MEMORANDUM

TO: Westport Zoning Board of Appeals

FROM: Philip C. Pires, Esq., Cohen and Wolf, P.C.

RE: Applicant's Response to Staff Report dated June 5, 2020

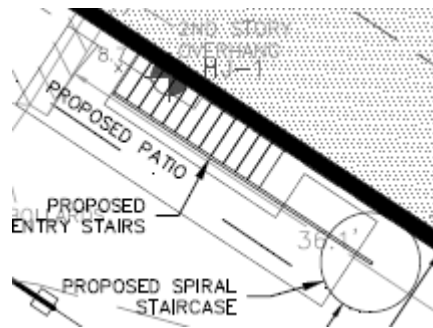
11. Although the applicant states it is their intent to build to the VE/Coastal AE standards they have proposed a double fence and light fixtures in the small portion of the property that is actually in the VE zone. These structures may not meet FEMA requirements and may not be consistent with the CAM Act.

The Applicant does not propose a "double fence." The proposed fences are independent of each other and do not overlap anywhere on the site. The fences will comply with FEMA requirements (i.e., the fences will have gaps to allow water to pass through them).

There is no FEMA standard applicable to outdoor lights. The fixtures that are shown in the Applicant's plans are UL1598 rated, which is defined as suitable for "a location in which water or

other liquidate can drip, splash, or flow on or against electrical equipment. A wet location luminaire shall be constructed to prevent the accumulation of water on live parts, electrical components, or conductors not identified for use in contact with water.” Accordingly, the fixtures selected are suitable for their intended use. The Applicant’s landscape architect (Michael D’Angelo Landscape Architecture LLC) will be available at the hearing to answer any questions that the ZBA has about the Landscaping Plan including, among other things, the light fixtures.

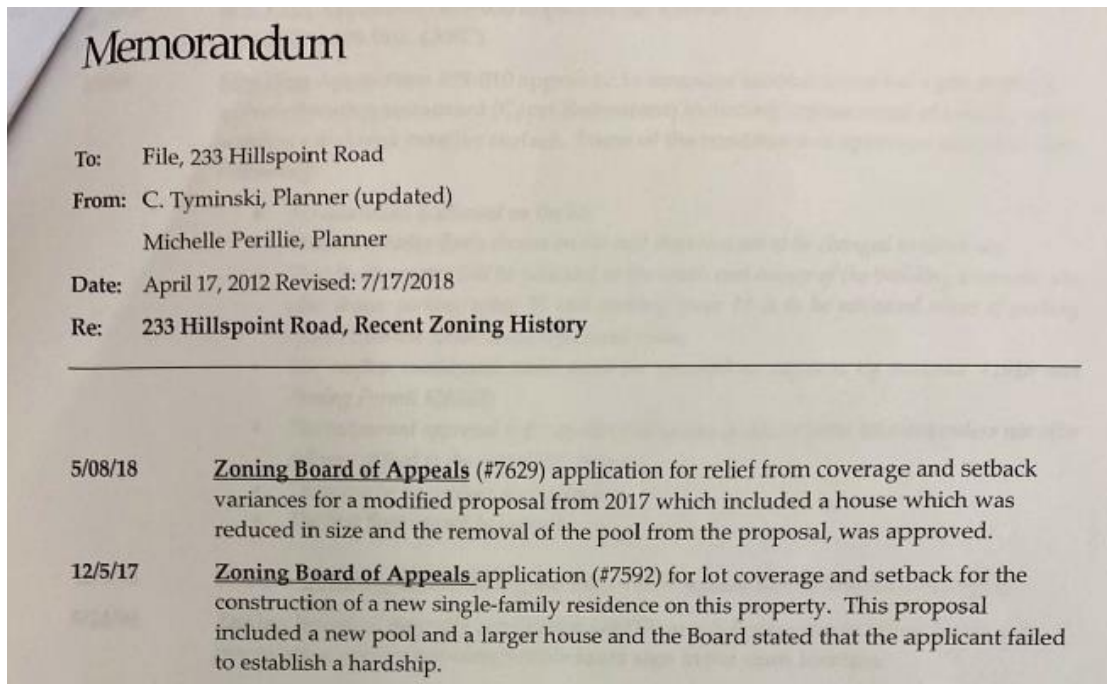
13. The current building design, constructed on piers, with a solid chimney where an open porch was approved and an elevator shaft that has been pulled to the street side facade of the structure, contradicts the ZBA guidance prior to the 2017 denial and may be out of scale and out of character with the neighborhood.

Both the Approved Variance Application and the Zoning Permit Plans (as well as the current proposed plan) resulted in a reduction in the size of the building of about 25% as compared to the 2017 denied variance application. Both the Approved Variance Application and the Zoning Permit Plans (as well as the current proposed plan) moved the house away from the side setback and

removed the proposed inground swimming pool. These were the concerns expressed by the ZBA in the 2017 denial.
